P-15773

S4925

PARTY'S NAME	LITWEL INDIA LTD., DELHI
PARTY'S DRAWING No.	AS PER DRAWING
ALLOY & TEMPER	HE9 WP
DESCRIPTION	ROUND HEAT SINK SECTION

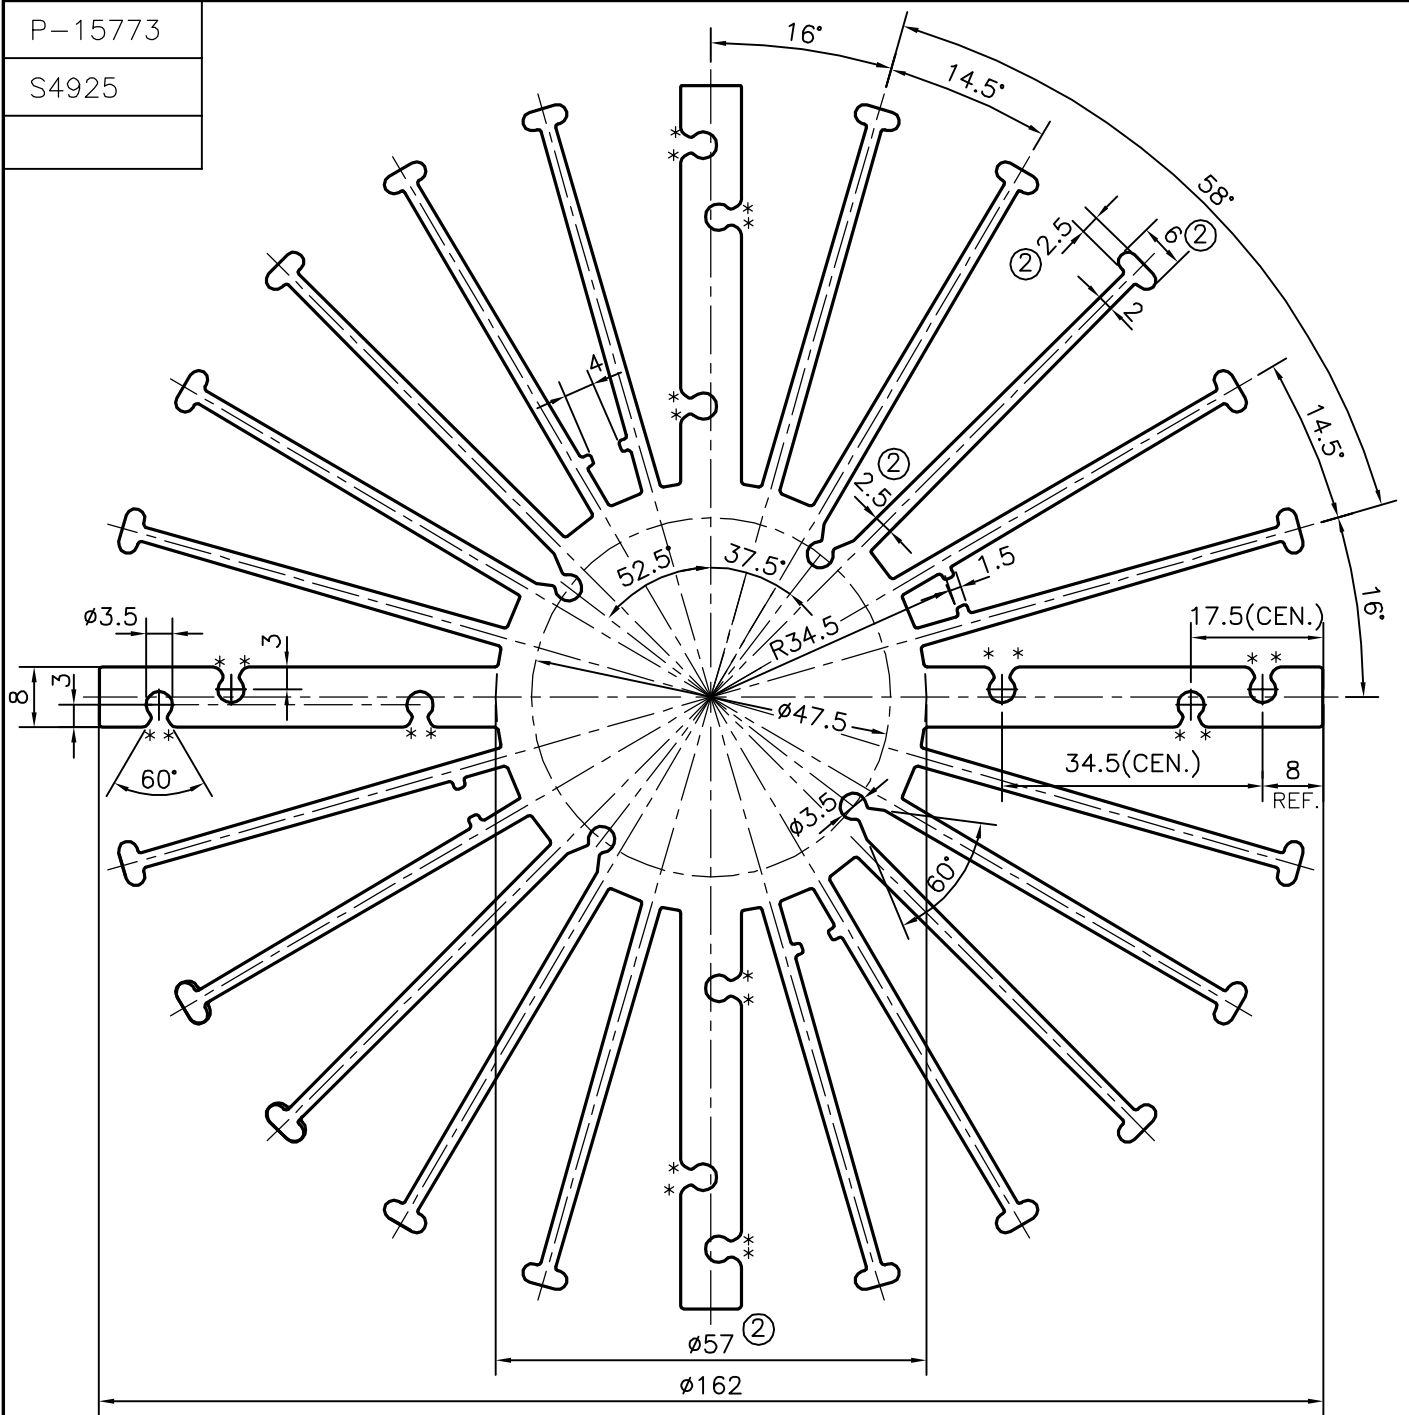
ISSUE-2 ②
 DIMENSIONS CHANGED FROM
 52.5 TO 57.00
 5.00 TO 6.00
 2.00 TO 2.50mm &
 WEIGHT ALSO CHANGED FROM 16.306 kg/M TO 17.634 kg/M
